## NOTICE OF HEARING BOARD MEETING LOWER TRENT CONSERVATION

O. Reg. 41/24 Permit Application #RP-24-232

## STAFF REPORT

**Date:** February 28, 2025  
**To:** Lower Trent Conservation Hearing Board  
**Re:** Ontario Regulation 41/24 application for permission RP-24-232 to develop within the Butler and Arena Creek floodplain and within 30-metres from a wetland feature  
**Prepared by:** Gage Comeau, Manager, Watershed Management, Planning and Regulations

Depth on 'Profile Line: House of Interest'

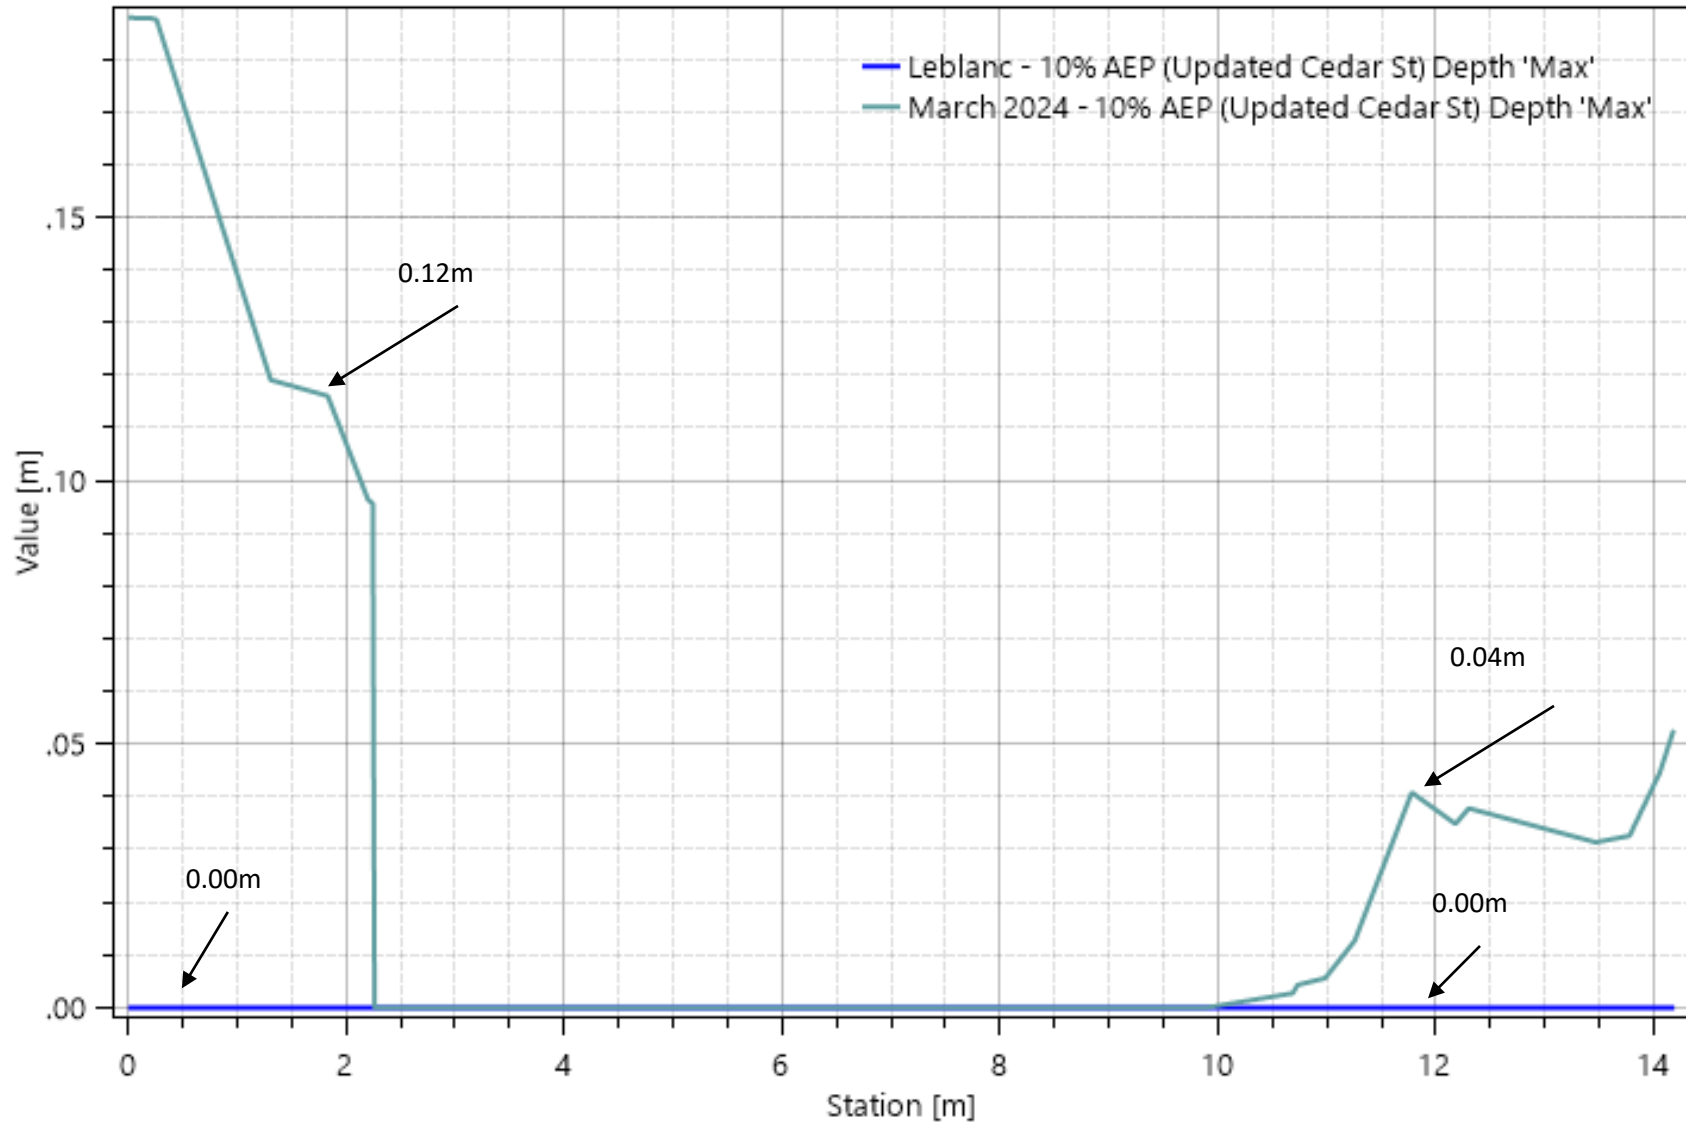
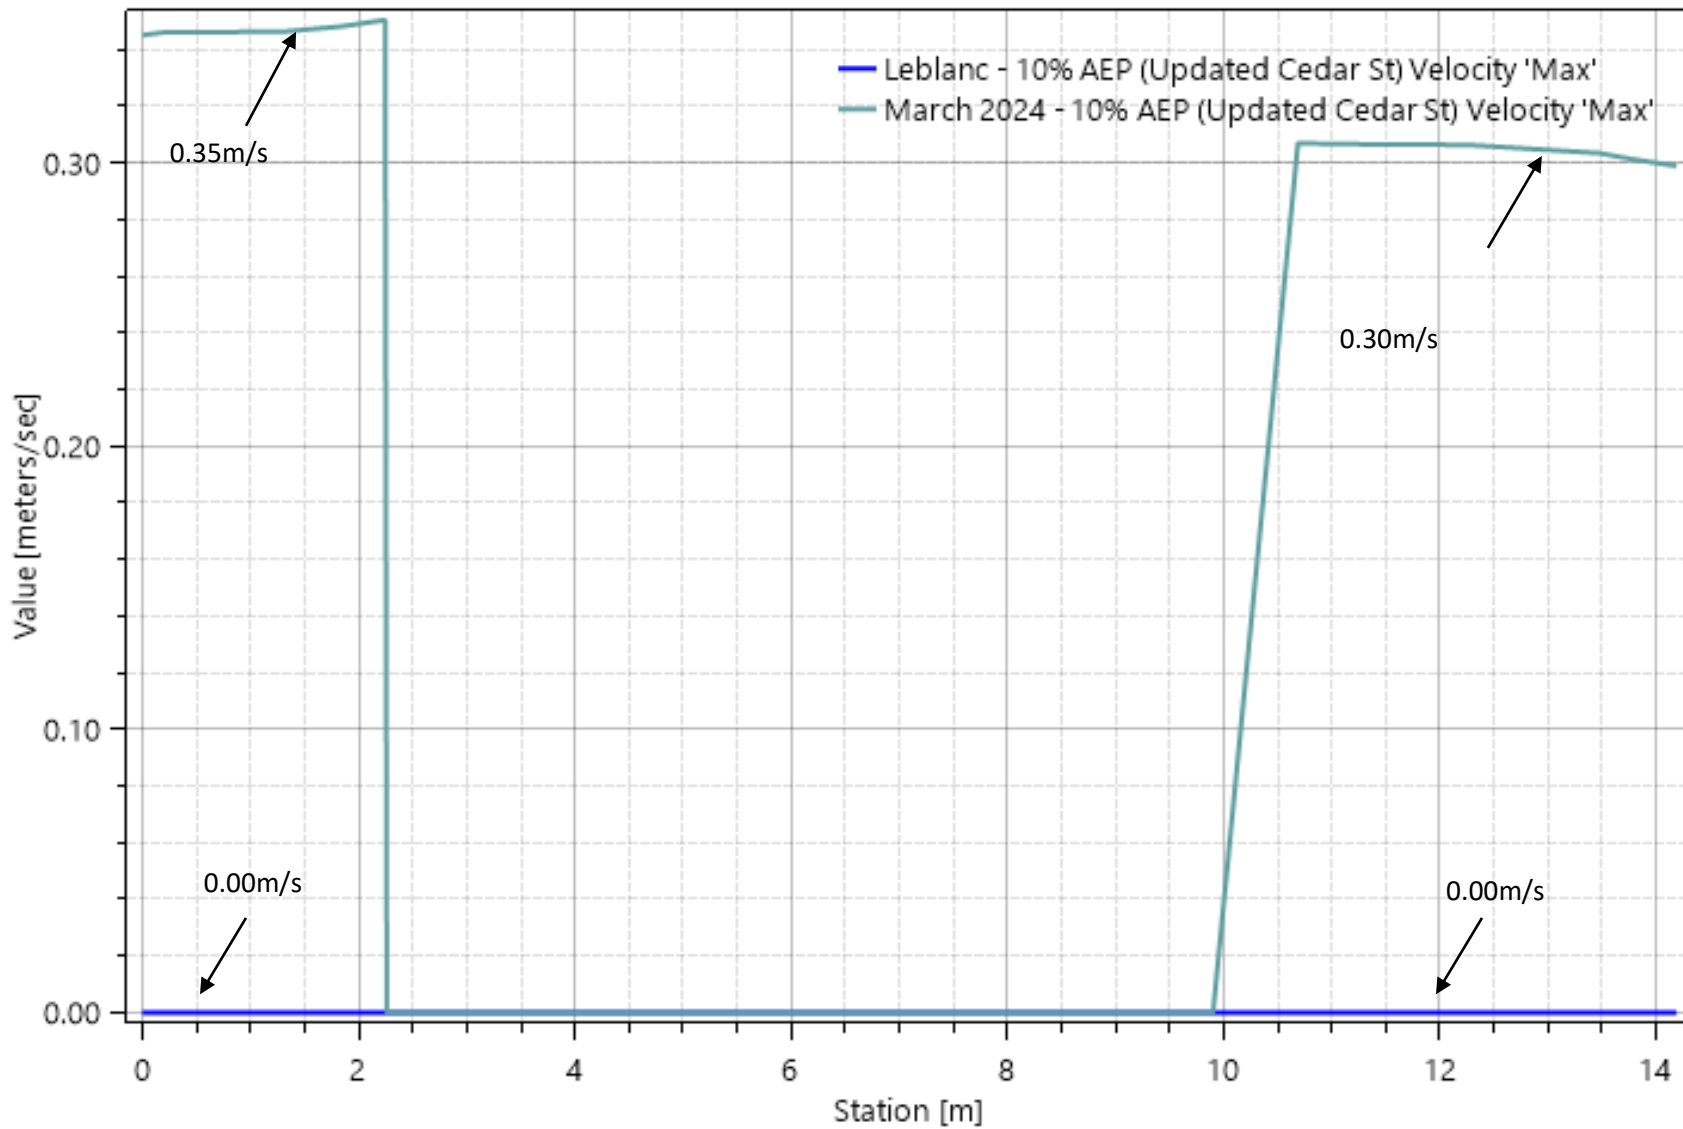
<b>Request #1:</b>	<p>The depth and velocity information before and after the flood mitigation plan at the house immediately upstream of Cedar Street.</p> <p>An assessment of smaller return period events was noted to be useful to confirm whether the house is negatively affected in events less than the regulatory storm.</p>

**Figures for Request #3:**

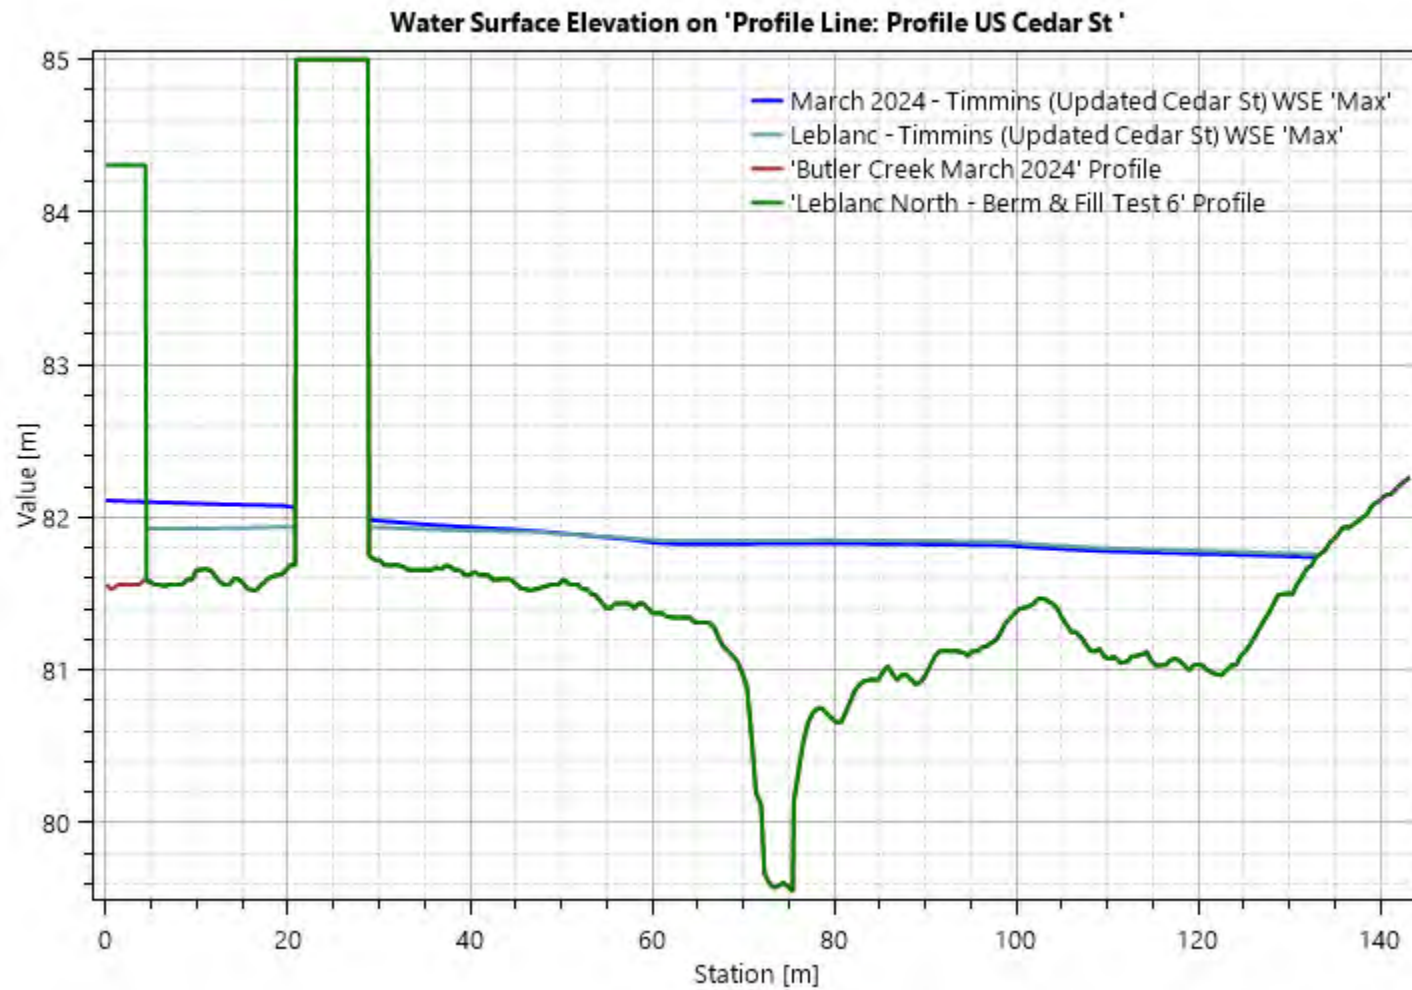
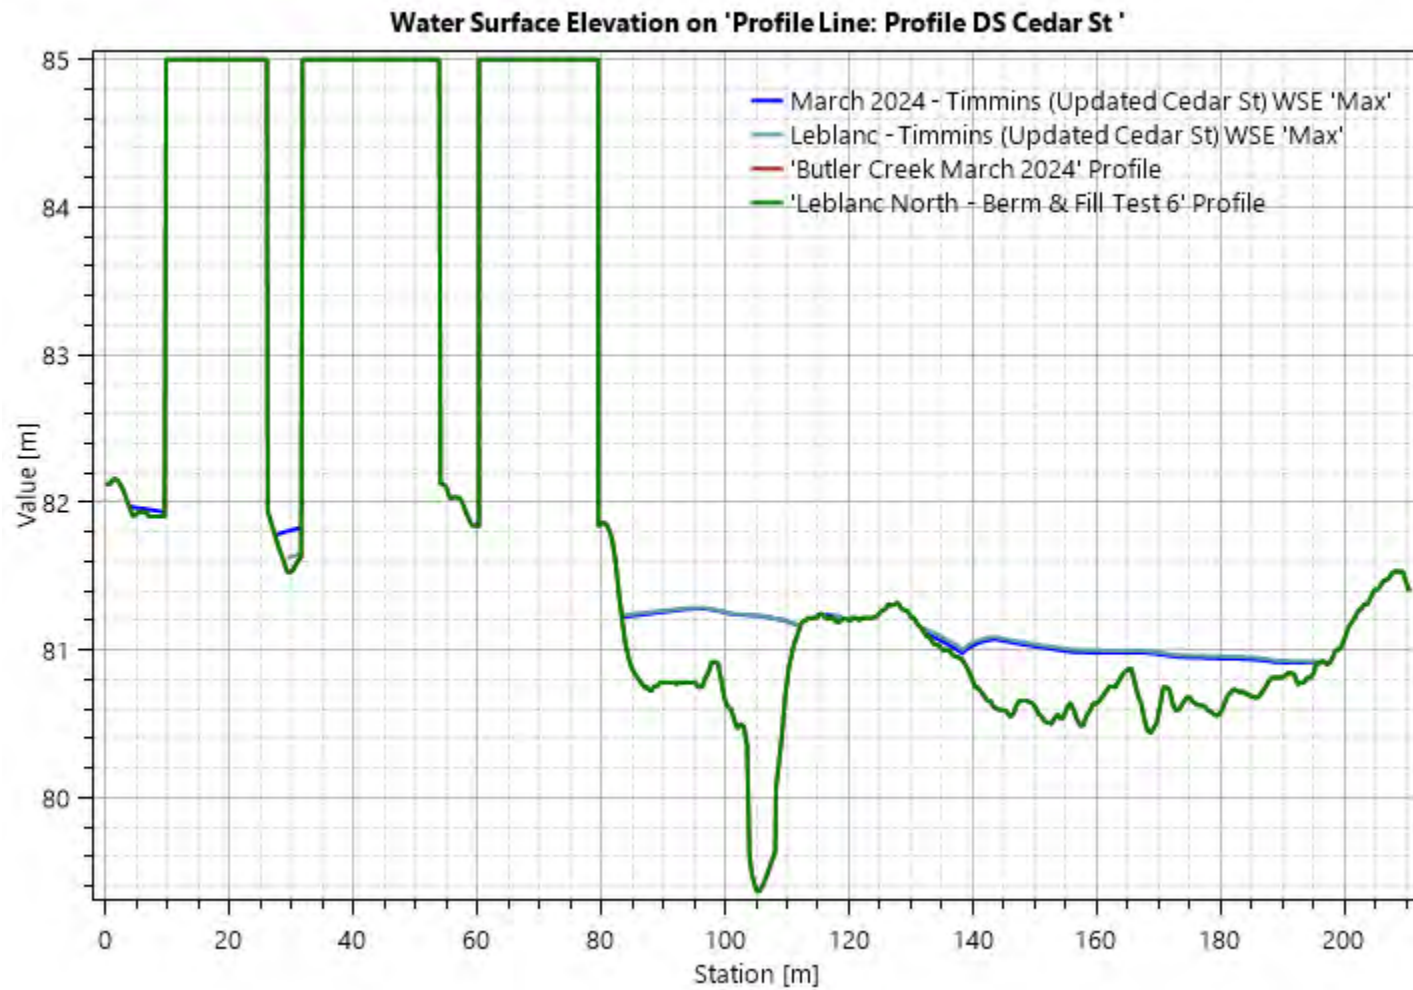
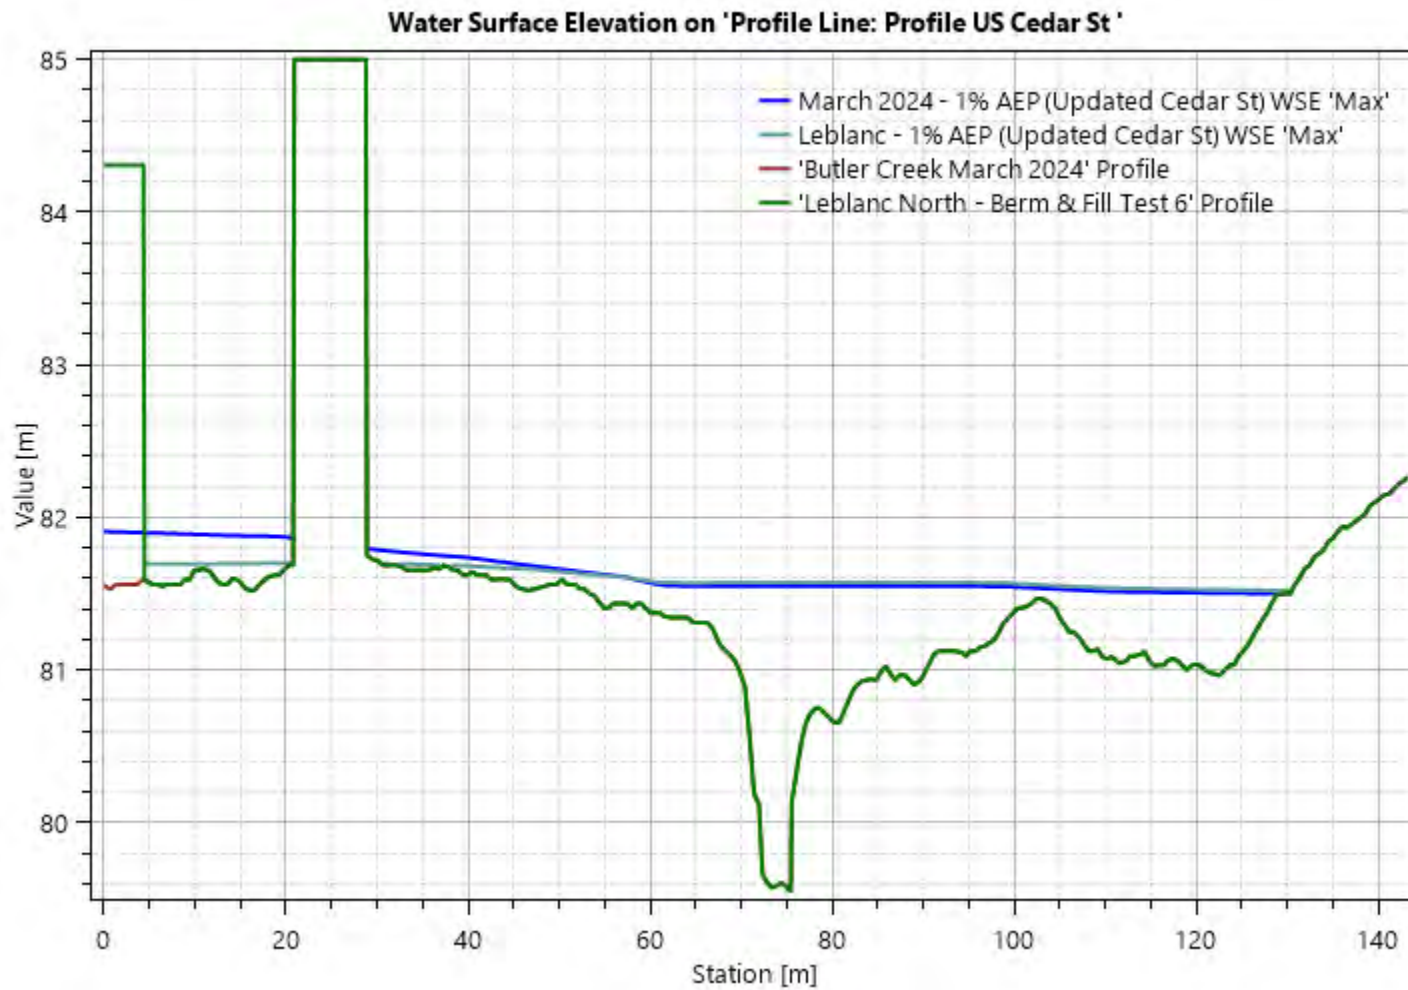
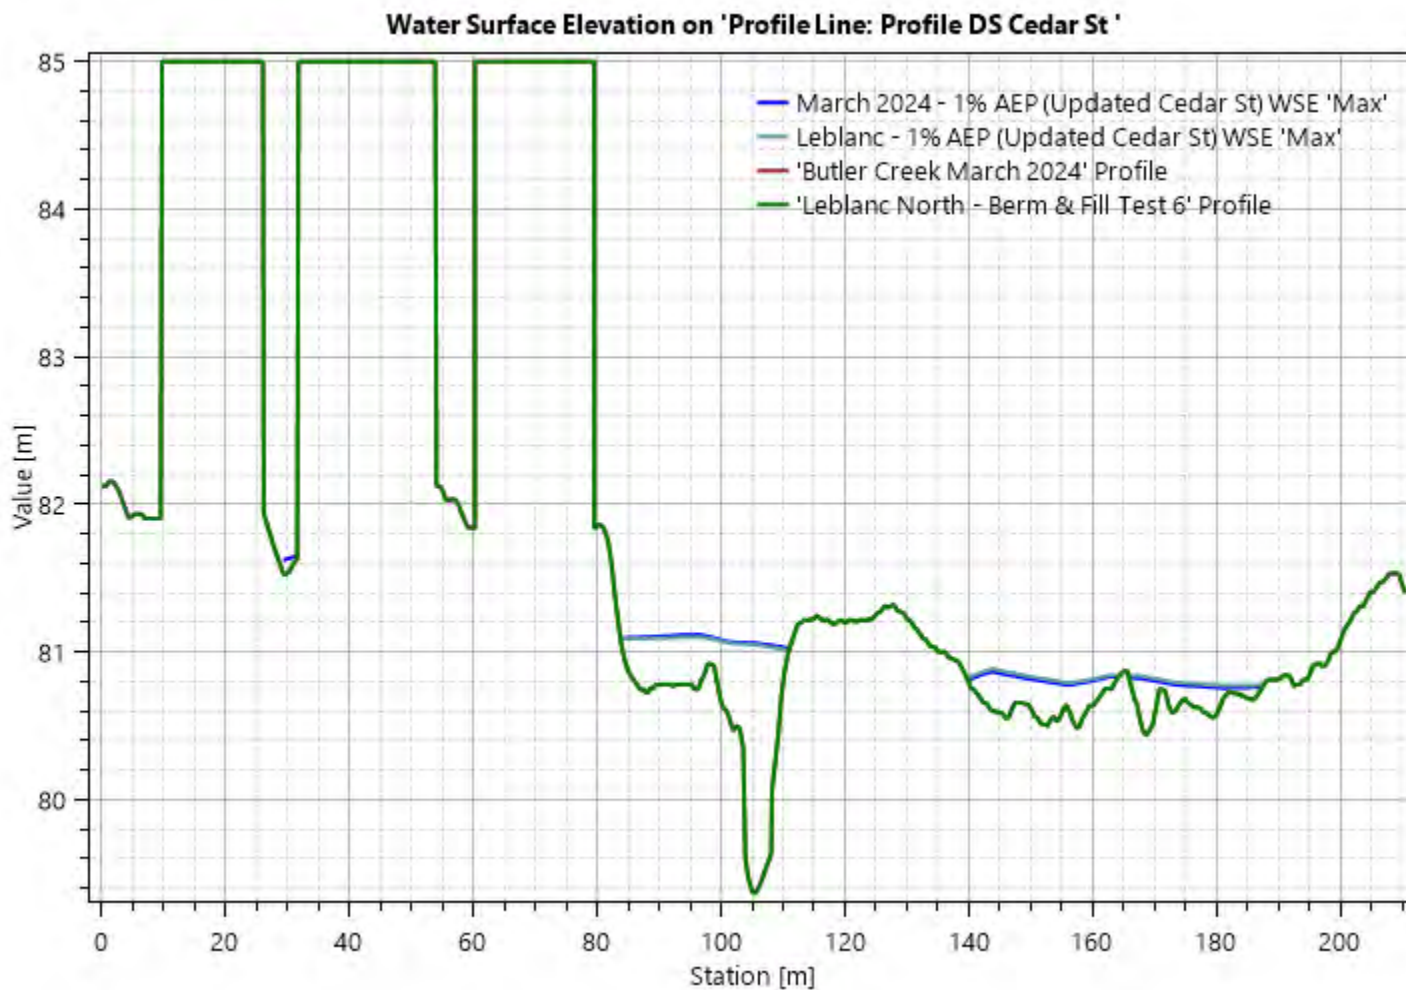
3. A profile of water surface elevations in the vicinity of Cedar Street (immediately upstream and downstream) was requested. Jewell to provide in revised report.

Immediate upstream and downstream cross section locations (black lines) for Cedar Street WSEL profiles:

Profile Immediately Upstream Cedar Street – Timmins with blue line existing and light green is proposed.

Profile Immediately **Downstream** Cedar Street – **Timmins** with blue line existing and light green proposed.

Profile Immediately **Upstream** Cedar Street – **100-Yr** with blue line existing and light green proposed.

Profile Immediately **Downstream** Cedar Street – **100-Yr** with blue line existing and light green proposed.
